Report: TAB REPORT
Function: Test, Adjust, & Balance
Date: 07/24/2023

06-24-24 WALGREENS #1769 - DENVER, CO

Issue List

EF2_DROP
07/25/2023

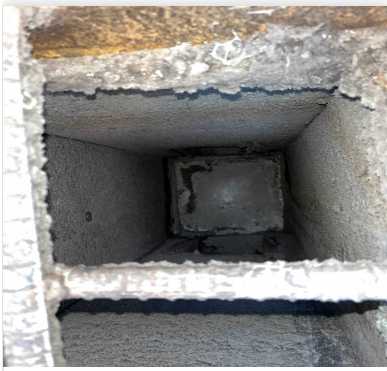
Issue Name : EF2 No Backdraft Damper
Description : No backdraft damper was found in the EF2 ductwork. Recommend installing to prevent drafting into the restrooms when the fan is not running.
Created By : National TAB **Assigned To :** National TAB - Stephen Tassinaro
Status : Open
Priority : Medium **Asset Tag :**
Originated Date : 07/25/2023 - Stephen Tassinaro - National TAB

- **06/17/2024 National TAB - Stephen Tassinaro**
 - No damper installed.

Dirty_Filters
06/19/2024

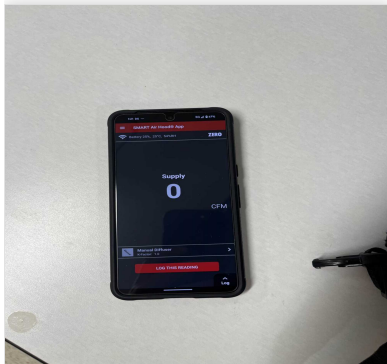
Issue Name : RTU Final Filters
Description : Recommended to install the appropriate sized MERV 8 or better throwaway filters in the RTUs for improved filtration.
Created By : National TAB **Assigned To :** National TAB - Stephen Tassinaro
Status : Open
Priority : Medium **Asset Tag :**
Originated Date : 07/20/2023 - Stephen Tassinaro - National TAB

- **06/17/2024 National TAB - Stephen Tassinaro**
 - MERV 8 filters now installed in all units, but they are dirty and due for replacement.
